TECHNICAL BULLETIN

POINT BLANK 2

Two problems have been identified on games with the following serial numbers:-

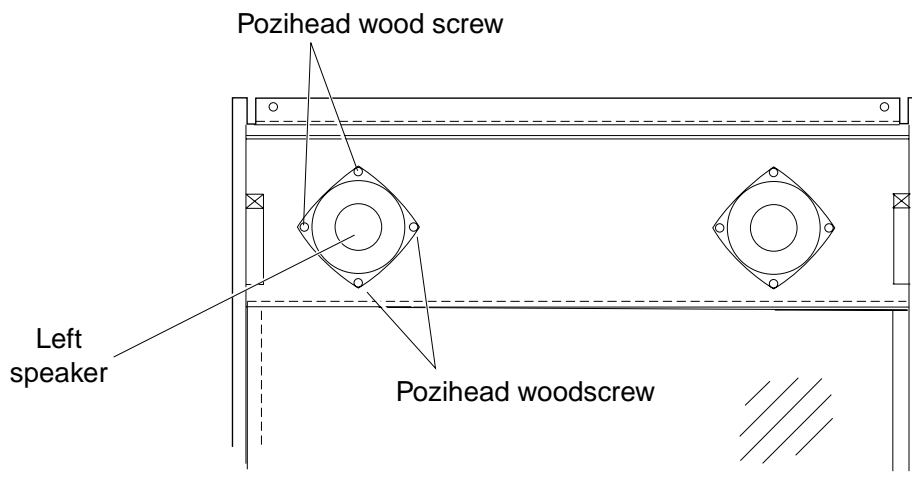
3. Remove 4 off pozi head wood screws and remove the left speaker only sufficiently to access the speaker connections.
Note: Take care not to damage the speaker cone.

4. Disconnect the speaker.
5. Cut off the 0.110" (smallest) receptacle from the white/violet wire and replace it with the supplied 0.187" receptacle.
6. Cut off the 0.187" receptacle from the white/red wire and replace it with the supplied 0.110" receptacle.
7. Reconnect the speaker and reassemble in reverse order.

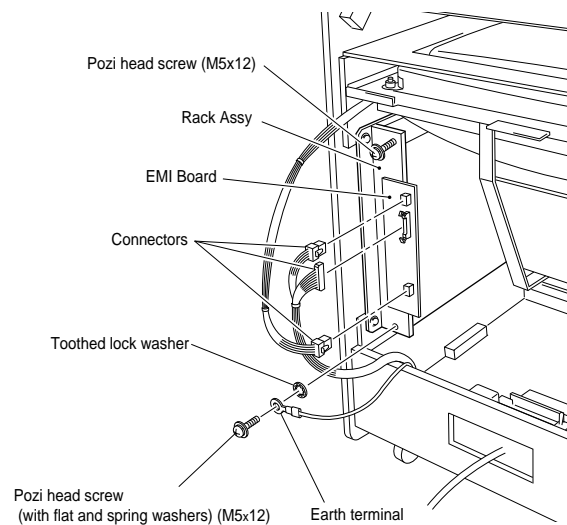
8. Open the back door and disconnect the connectors from the EMI Board.
9. Remove 2 off pozi head screws (M5x12) from the rack assembly, taking care not to lose the toothed washer behind the earth terminal.

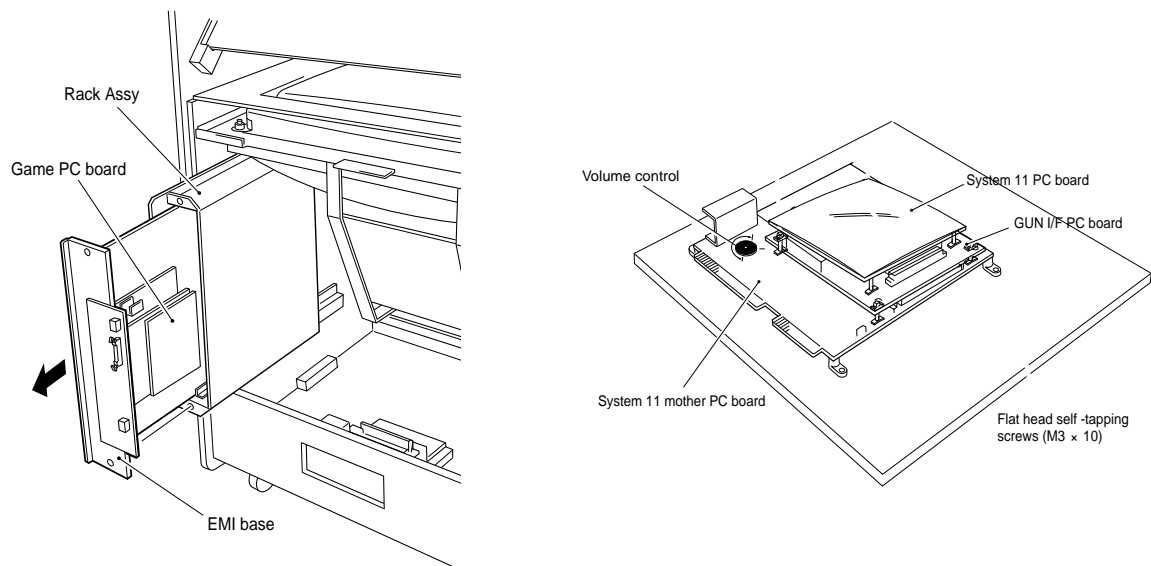
10. Carefully withdraw the game pcb assembly from the rack assembly only sufficient to gain access to the volume control on the System 11 Mother PC Board.

11. Turn the volume control clockwise to approx $\frac{3}{4}$ of its travel.
12. Ensure that the System 11 Mother PC Board edge connection is fully seated in the edge connector housing of the EMI PC Board and reassemble in reverse order.
